From: drainage <drainage@midsussex.gov.uk>
Sent: 11 March 2026 12:04:32 UTC+00:00
To: "Stefan Galyas" <Stefan.Galyas@midsussex.gov.uk>
Cc: "drainage" <drainage@midsussex.gov.uk>
Subject: 2026.03.11 Re: DM/26/0507 - 10 Woods Hill Lane Ashurst Wood East Grinstead
West Sussex RH19 3RL

We understand the proposed application is for a double storey side extension. Double storey porch extension.

The Flood Risk Assessment provided by the Applicant has been reviewed and we would comment as follows:

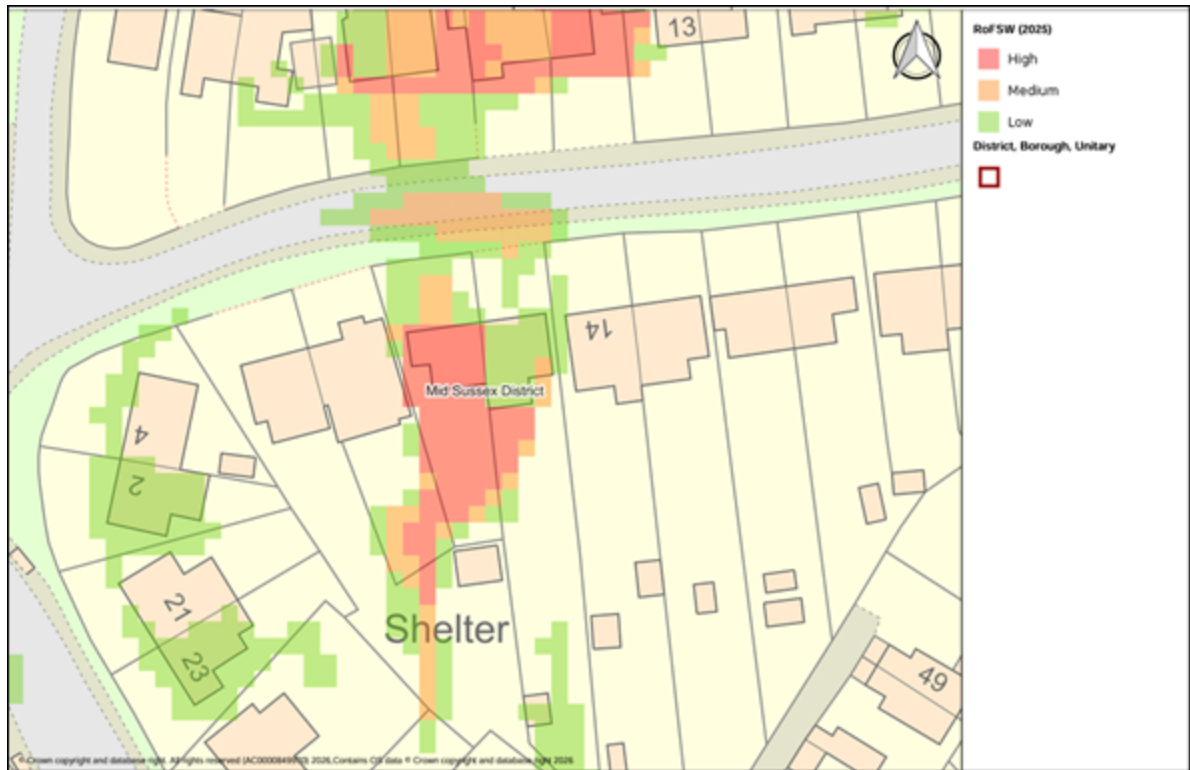
However, the Environment Agency's Risk of Flooding from Surface Water (RoFSW) mapping indicates that the site is shown to be at very low to high surface water flood risk (comparable to Flood Zones 1 to 3b). The area of high surface water flood risk is associated with a flow path running from the rear to the front of the property.

The applicant has failed to demonstrate that the proposed development is located outside of the 1 in 30-year surface water flood extent. In the absence of such evidence, and based on the latest flood risk mapping, part of the site is considered to fall within the equivalent of Flood Zone 3b (functional floodplain).
